ALERT SERVICE BULLETIN

429-25-64

MODEL AFFECTED: 429

SUBJECT: NON-CONFORMING FUEL PROBES,
REPLACEMENT OF.

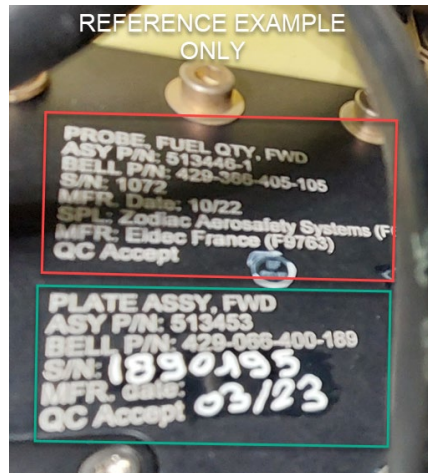
If reference "SB 72B207-28-001" is found written on the plate assembly, this indicates it was repaired at the supplier and is not affected by this Alert Service Bulletin.

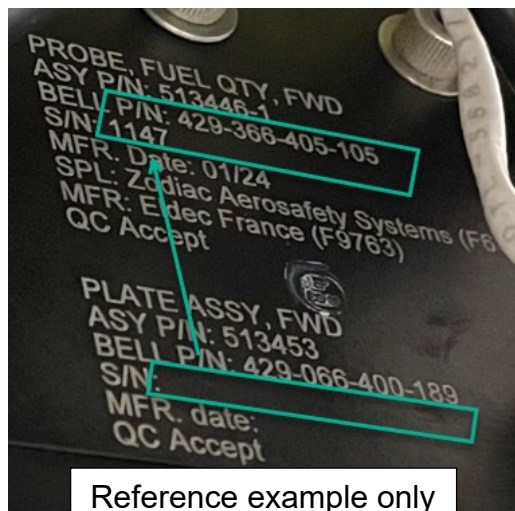
Fuel probes replaced in the field may have a plate assembly identified without a serial number. If no serial number at the plate assembly level is found, this indicates assembly not affected. Subsequently, refer to the fuel probe part number and serial number to determine if affected per Table 1.
